# PREDETERMINATION SETTLEMENT AGREEMENT

CP# 09-18-72461  
HUD# 07-18-0080-8

Complainant specifically alleged at 1400 Walnut Street, Flux Apartments (“Flux”), one feature in the common areas and three features within two of the covered units appeared inaccessible to a person utilizing a wheelchair for mobility – (1) the heights of the midlines of the keyholes at the top four rows of the mail compartments at the wall-mounted mailbox station were calculated to be 66 1/2” (top row), 62 5/8” (second to top row), 59 1/8” (third to top row), and at 55 5/8” (fourth to top row)– all of which are higher than the 54”-maximum allowed for a parallel approach by persons using a wheelchair; (2) the height of the interior threshold at the sliding glass doorway in Unit 314 was measured at 15/16”, which exceeds the 1/4”-maximum allowed for interior thresholds at sliding glass doorways if there is 1:2 beveling present, which was observed to be lacking; (3) the height of the midline of the upper electrical outlet located between the toilet and the bathroom sink was measured at 48 3/4” in Unit 304, which is more than the maximum height of 46” that is allowed for electrical outlets located above an ob

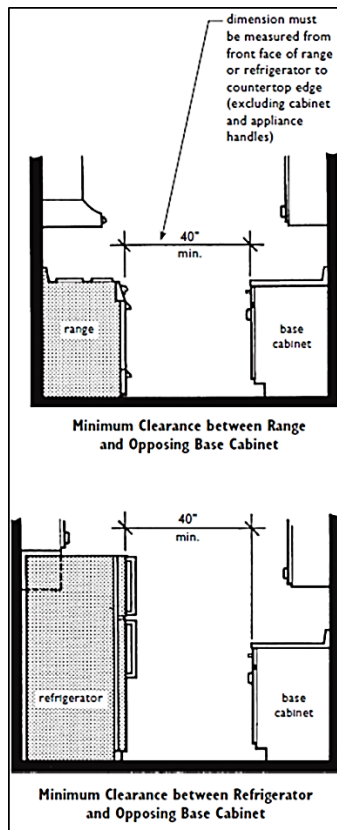
(a) The parties agree the width of the path between the kitchen island and opposing features in Units 304 and 314 is less than the 40"-minimum minimum width required by the Manual.

(b) Respondents agree to increase the clear width of the path between the kitchen island and opposing features to no less than 40" in Units 304 and 314 by reinstalling the countertop on the kitchen island further away from the opposing features to meet the 40"-minimum width, as required in the Manual. Respondents agree to measure the clear width of the path as indicated in the figure below (*See Manual at page 7.7*)
